Development Facilitation Program PPA-990**188-202 Swan Street, Cremorne**

In response to the Project Eligibility Letter issued on 6 March 2026, please find below a response to the preliminary comments:

Preliminary Comments & Responses

Figure 1 – South east view (Urban Context Report – Cox)

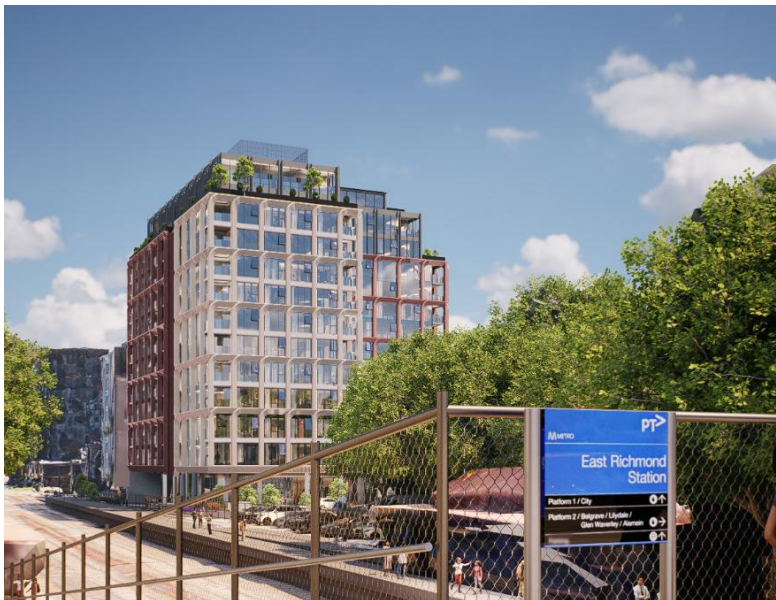
- *Further refine façade design and materials to reduce perceived bulk at the rear and in long-range skyline views, consistent with DDO26.*

- Amendment to façade framing elements to provide a variation in colour along facades (refer Figure 1), including:
 - Beige coloured masonry elements with expressed horizontal elements and single height glazing along part of south, east and north façade
 - Burgundy coloured masonry elements expressing a double height presentation of glazing along part of south, west and north façade
- The colour variation is brought to ground along the pedestrian link and southern edge of the building (refer Figure 2).
